522-552 Flinders Lane, Melbourne

Planning Permit Application PA2302533

Officer Assessment Report
Development Approvals & Design

Figure 15 – Demolition Plan (Source: Hassell Architects)

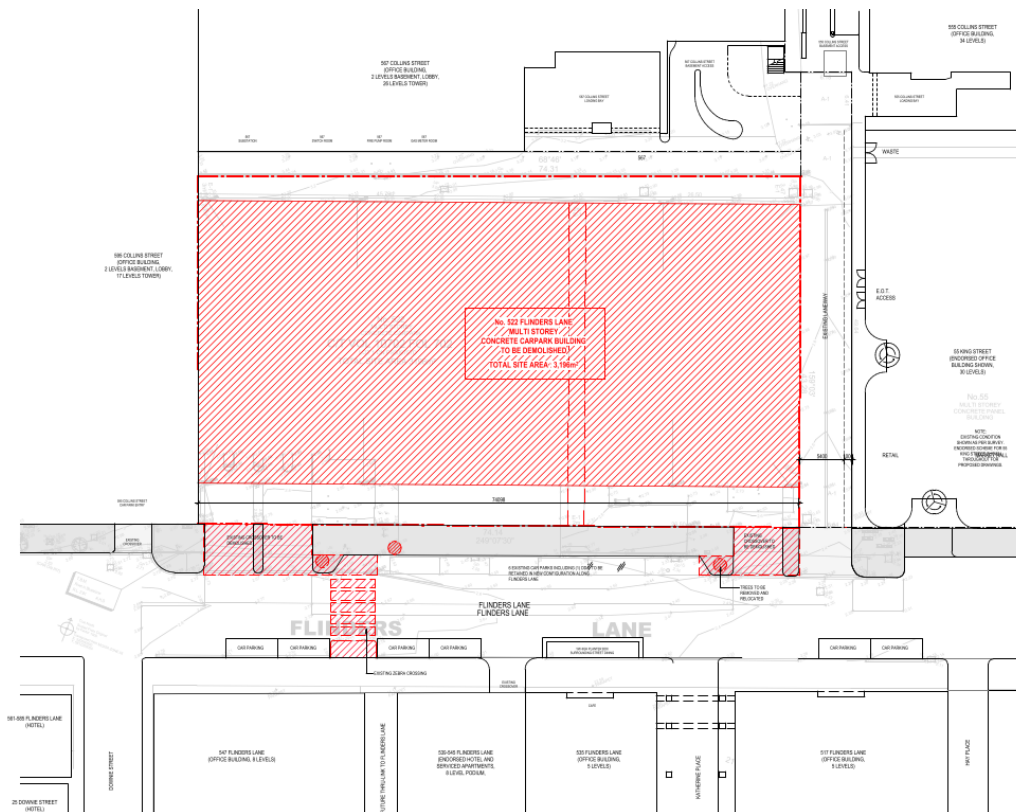
- 122. As shown in Figure 15 above the proposed development includes alterations to the Flinders Lane streetscape, including removal and replacement of street trees, removal of crossovers, adjustments to the on-street car parking, and landscaping.

- 123. With the exception of the removal of the crossovers (which are redundant based on the proposed layout and rear access via the laneway), the Council recommended a condition requiring that works outside the title boundary be deleted from the plans. The Council referred to comments made by internal department, which highlighted there are a number of statutory processes that public street works must go through prior to approval (should they be approved). These processes may include public consultation.

Figure 19 – Extract of TP_0403 (Elevations – Detail) prepared by Hassell Architects dated 18 March 2024

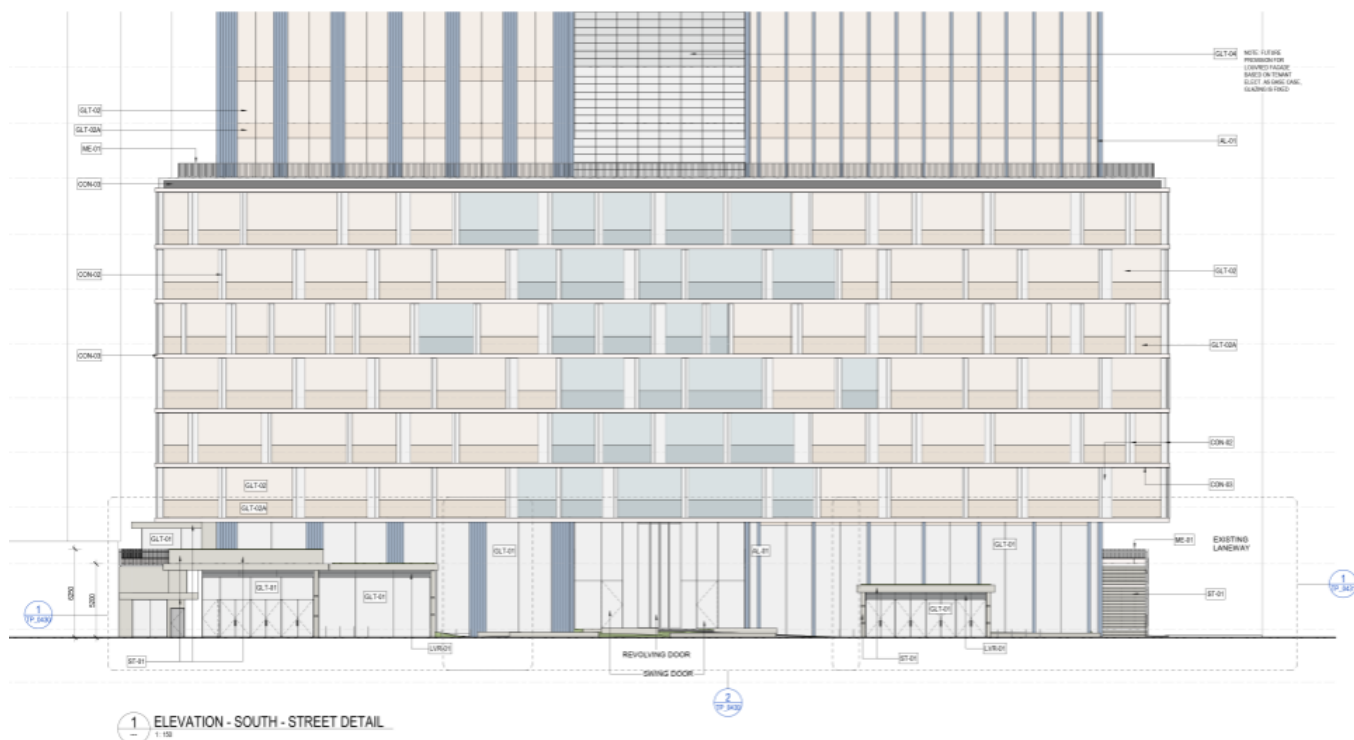
As described above, the VDRP recommended further subtle modulation to mark the primary pedestrian entrance from Flinders Lane. In response, the applicant provided revised plan TP_0403 (Elevations – Detail) prepared by Hassell Architects dated 18 March 2024 (refer Figure 19 below) which varies the glazing treatment above the pedestrian entrance to emphasise and reference the pedestrian entrance. The variation in the glazing, combined with the other modulations discussed above, provides for a fine grain and visually interesting street wall that responds to its context. DTP supports the inclusion of a condition to give effect to the concept as shown in Figure 19.

The detailed design language of the podium will be further refined through a recommended condition requiring a façade strategy

which will strengthen the use of solid materiality to better reference the materials that characterise the immediate context.

Figure 20 – Concept prepared by Hassell Architects to integrate the tower facade language with the roof plant

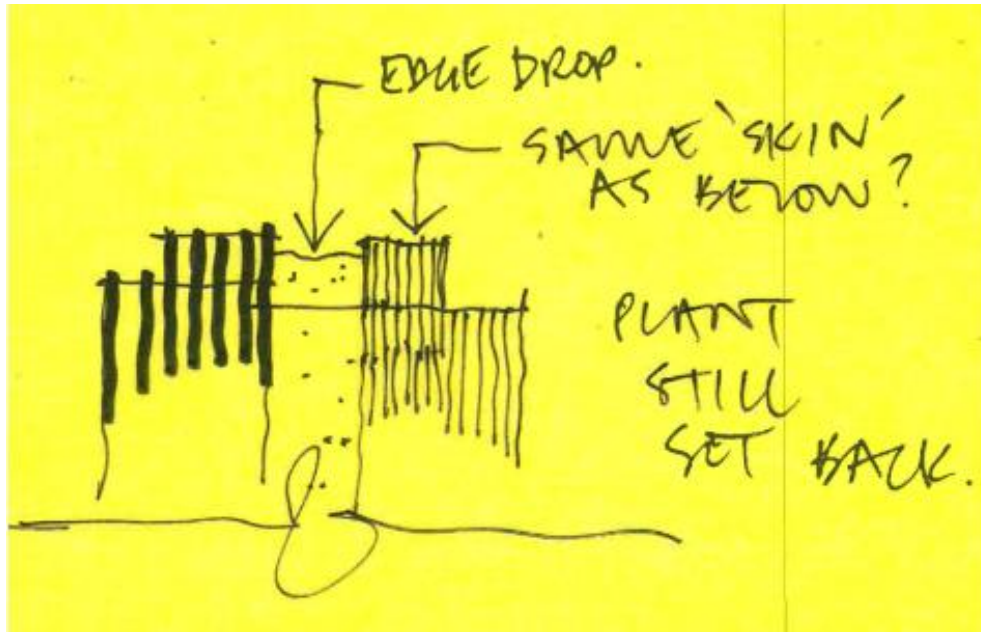
The DDO1 encourages rooftop plant, services and antennae to be integrated into the overall building form.

The OVGA in the VDRP report encouraged the architects to consider how the main façade could be extended to fully conceal the roof plant and consider how the screening types, proportions and form can be integrated within the overall building composition.

As described by Hassell in the submitted architectural package, the form of the roof level plant has been shaped to ensure that the plant enclosure emphasises the notion of 'two towers / two rivers' proposition (Refer Figure 17 & 18 above and Figure 20 below). This allows the building crown to sit comfortably on the top of the towers as a complimentary element within the overall built form proposition. This subtle adjustment to the expression of the plant enclosure establishes a consistent reading of the building form from distant vantage points and reinforces the design narrative.

Figure 21 – Maximum vs Adjusted tower floor plate under DDO10 (Source: Hassell Architects)

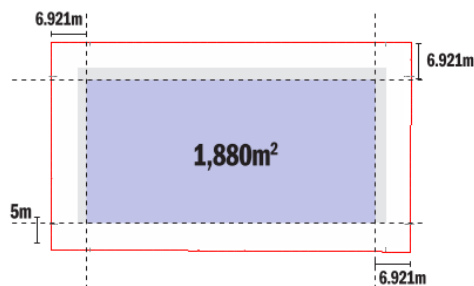
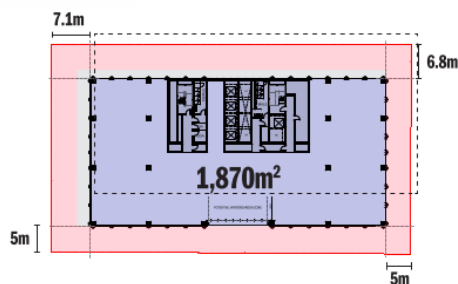
The increase in the depth of the central tower recess by 500 mm as discussed above does not alter the compliance with tower floorplate calculation as there is no additional floor area and it does not alter the side and rear setbacks.

The adjusted floor plate is designed and spaced to reduce impacts including visual dominance on surrounding buildings (by shifting the tower closer towards the east private laneway and Flinders Lane whilst maintaining a minimum 5 metres setback). The siting of the tower toward the east boundary will adequately provide for the equitable development of the adjoining sites (and existing buildings) to the east and north (minimum 10 metres building separation) and does not unreasonably reduce privacy, outlook, daylight and sunlight to these buildings which are used for commercial purposes.

Figure 15 – Applicant submitted shadow diagrams at 2pm on 22 June (Source: Hassell Architects)

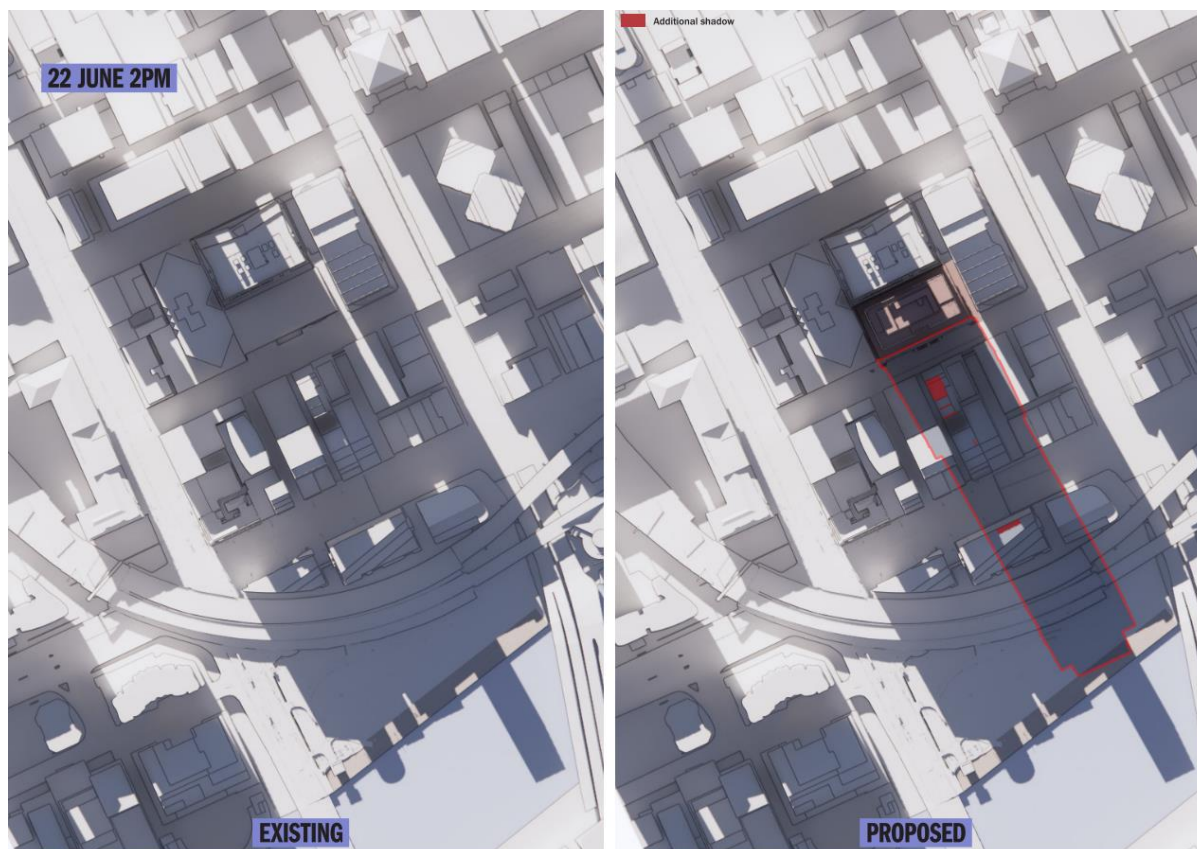
149. The submitted architectural package by Hassell Architects includes a detail shadow analysis of the proposed development within the parameters outlined in the DDO10. The shadow analysis shows that the shadow cast by the proposed building are greatest at 2pm on the 22 June as shown in Figure 25 below.

150. DTP's 3D Visualisation team provided a review of the submitted shadow diagrams and prepared a shadow analysis. The shadow analysis which shows that there is a period of up to 30 minutes which occurs on June 22 (the winter solstice, being the greatest extent of shadows between 22 April and 22 September). The Council in their assessment indicated that this results in a maximum of approximately 98 sqm of additional shadows being cast (or 0.69 per cent of the total Batman Park area).

Figure 27 Existing wind conditions

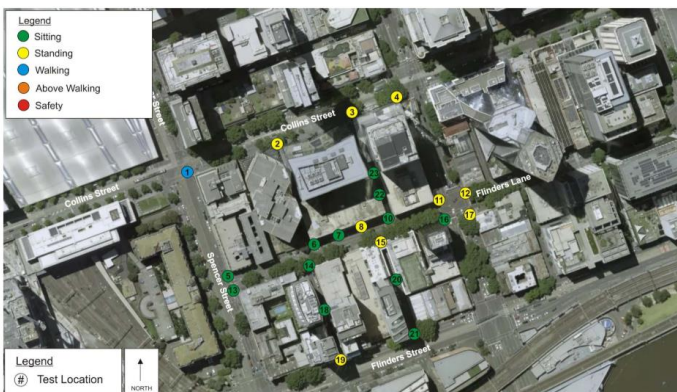
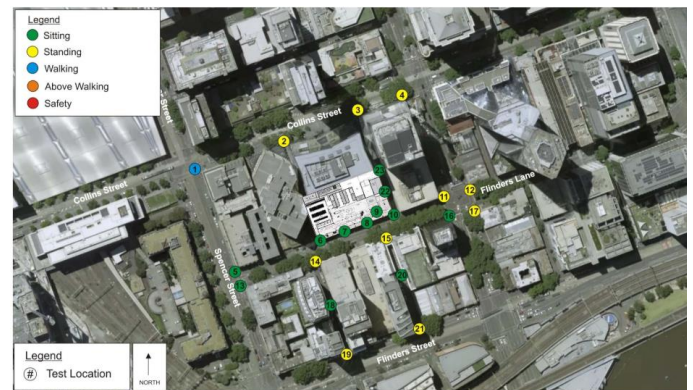
157. The wind conditions on the upper level terraces at Level 3, 8 and 27 have been shown to satisfy the standing comfort criterion, with conditions at most Test Locations achieving the sitting comfort criterion. The wind conditions at all measured Test Locations have been shown to satisfy the Standard DDO10 safety criterion.

158. The report also confirms that there are no wind mitigation design methods required on the building to achieve these objectives.

Figure 29: Ground plane landscaping and finishes (Source: Hassell Architects)

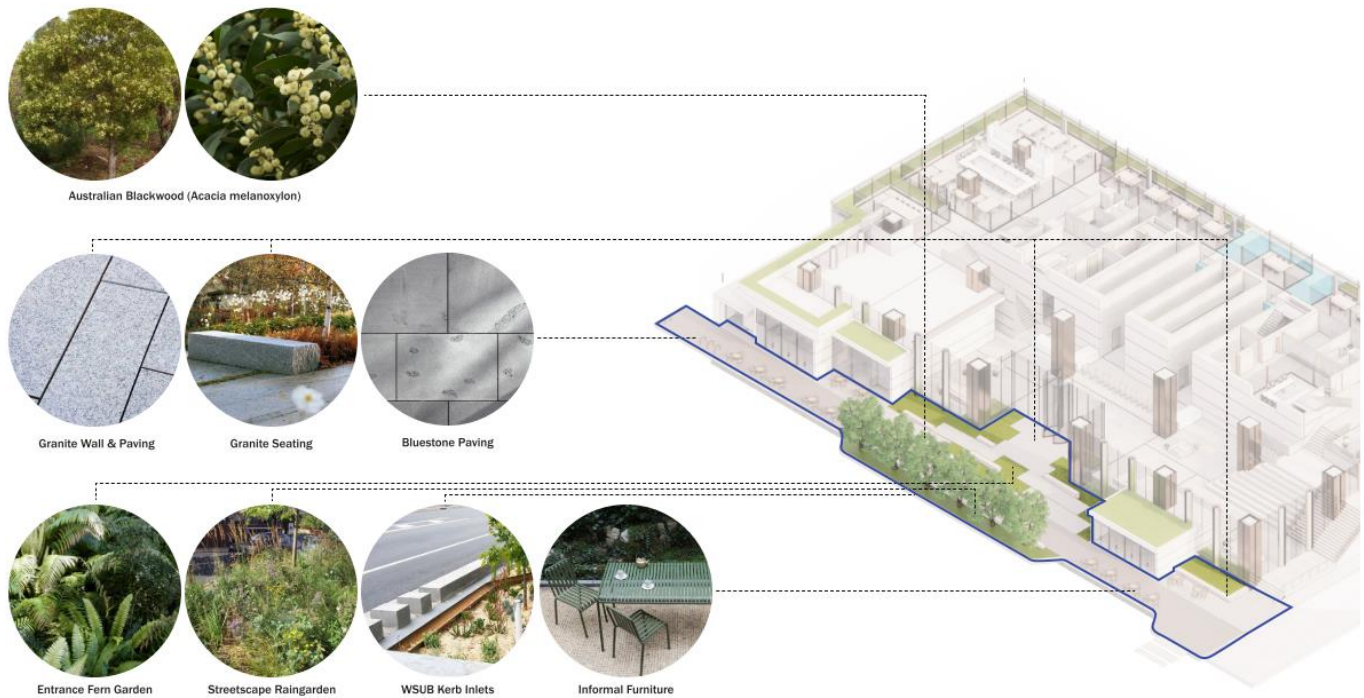
170. At ground level (as shown in Figure 29), the concept shows a new landscaping treatment is proposed with a fern garden at the lobby entrance and Australian Blackwood trees along the pedestrian footpath. Further planting is also included on the upper ground level within a planter box, which will include shade-tolerant plants. The plans also show an upper ground 'roof top' garden located along the southern balcony. It is noted that the Council recommended deletion of works (i.e. blackwood trees) outside the title boundary, with these details to be resolved through separate discussions with the permit holder.

- 176. The council has recommended conditions relating to the provision of a Landscape Plan generally in accordance with the submitted landscape concepts and a Tree Protection Plan (TPP). DTP supports the inclusion of conditions addressing these matters in the permit.

Figure 30: Level 7 terrace landscaping and finishes (Source: Hassell Architects)

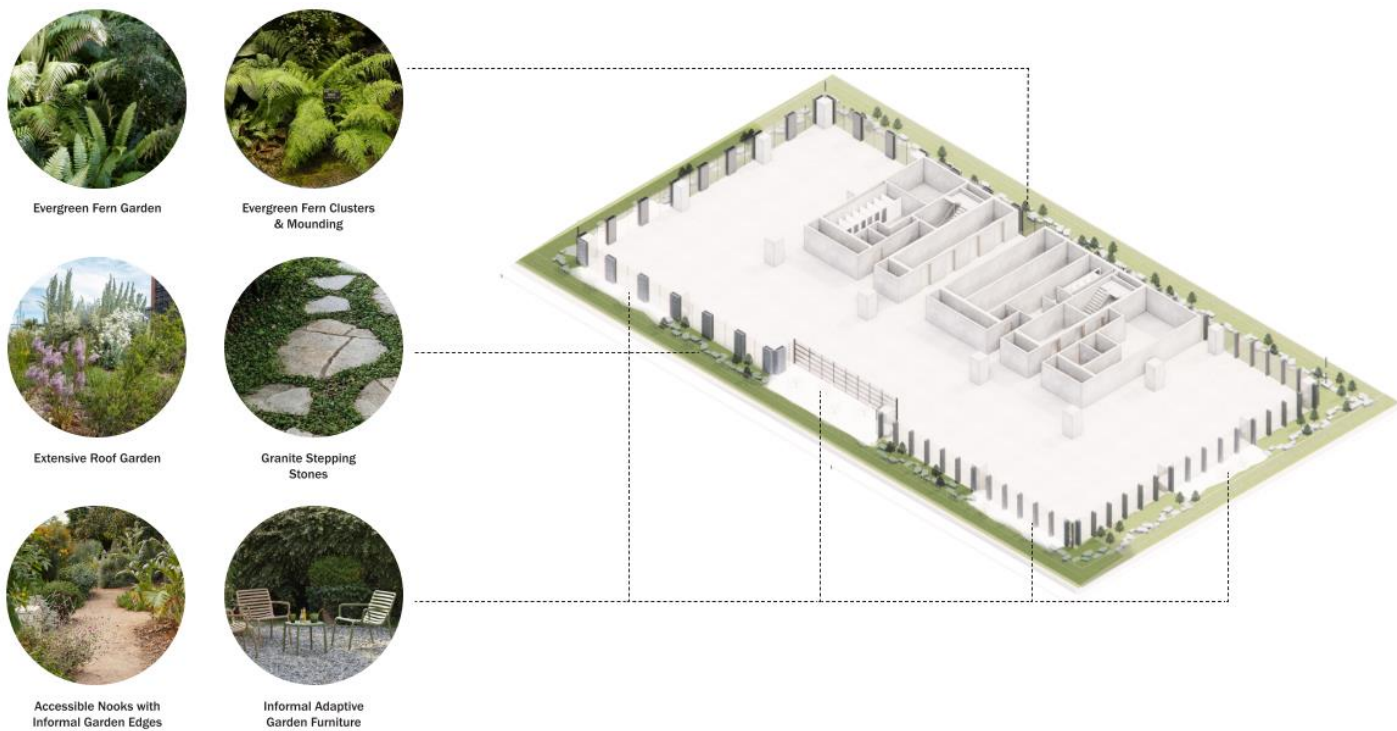
171. Capping the podium (as shown in Figure 30), Level 7 will feature a terrace which will have various planting shifting from evergreen fern topology to a mixture of native species. Small accessible nooks provide areas for relief whilst stepping stones connect these zones through a series of mounds and depressions within the landscape. The curated selection of plant species, with particular consideration around orientation and shading will respond to the Melbourne climate.
